DEPARTMENT OF THE ARMY
U.S. ARMY ENGINEER DISTRICT, SACRAMENTO
CORPS OF ENGINEERS
1325 J STREET
SACRAMENTO, CALIFORNIA 95814-2922

Draft Environmental Assessment/Initial Study for Levee Repair of 25 Erosion Sites Volume 1: Sacramento River Bank Protection Project

REVISED Conceptual Illustrations

Figure 2-1 Conceptual Cross Section of Design 1

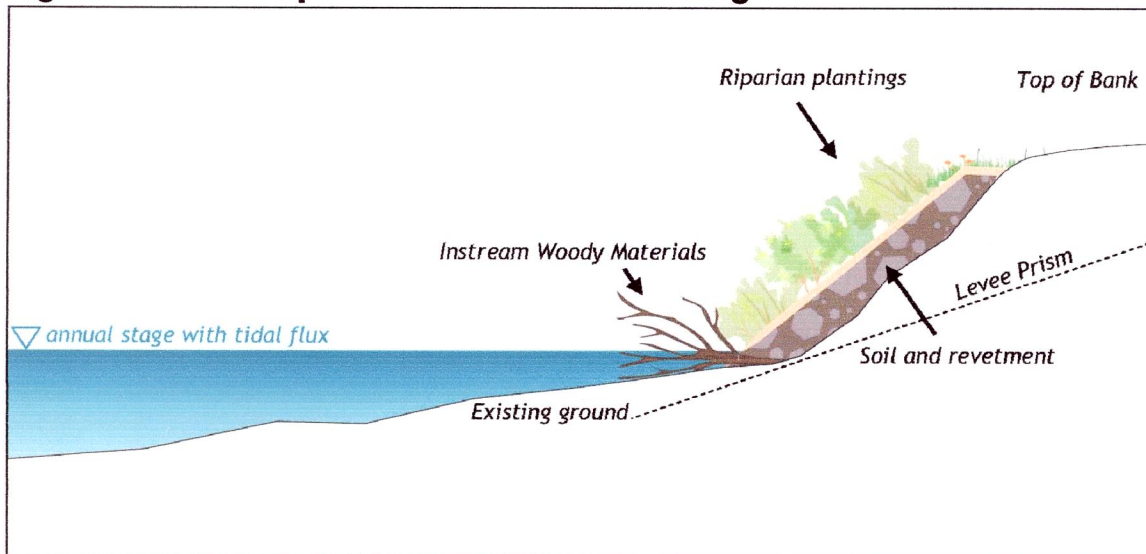
Figures 2-1, 2-2, and 2-3 of the draft Environmental Assessment/Initial Study (EA/IS) provide conceptual illustrations of the proposed designs for levee repair. Please note that these conceptual illustrations are not drawn to scale and do not illustrate the actual placement or volume of revetment, instream woody material, riparian plantings, and existing vegetation. Appendix A and Appendix F of the draft EA/IS provide more detailed information for the repair designs proposed for each erosion site.

Please note that vegetation to be planted on the levee slopes would be in conformance with U.S. Army Corps of Engineers, Sacramento District, criteria for vegetation in the vicinity of levee structures. No woody plants or plants that would obstruct the view of the levee would be planted within 15 feet from the waterside toe of the levee slope (vegetation-free zone). Figures 2-1, 2-2, and 2-3 have been revised to replace the label of “Top of Levee” with “Top of Bank.” Vegetation is not planted to the top of the levee. Vegetation is planted on the bank of the levee greater than 15 feet away from the waterside toe of the levee slope. Revised versions of Figures 2-1, 2-2, and 2-3 are provided below.
